Access Compliance Report Public Rights-of-Way (Curb Ramps)

Main Street: CHANTICLEER_RD		Cross Street: PERDIDO_ST		Location:	SE
ADA ID: RPRK210923112241	Ramp Type:Type 1 - Perpendicular Diagonal Initial Pass/Fail: Fail		Overall Compliance: No	Severity Score:	15
Codes/Mitigation Info/Possible Solution			Field Measurements/Component Compliance

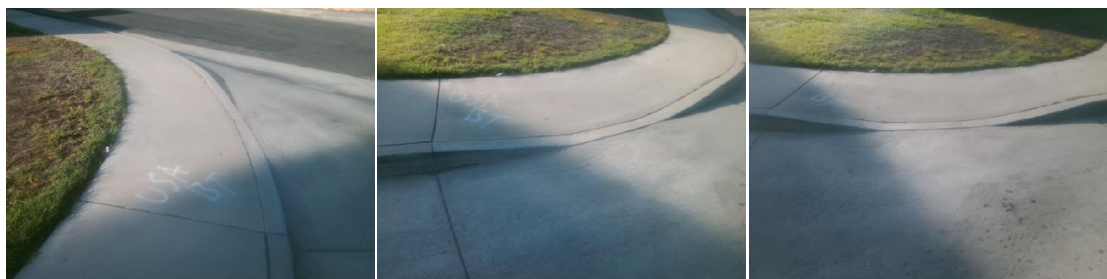
R204.3, R304.2.2, R302.7.2, STD 1115

Remove & Replace Curb Ramp With Two New Directional Ramps or Equivalent. Grind Gutter Lip.
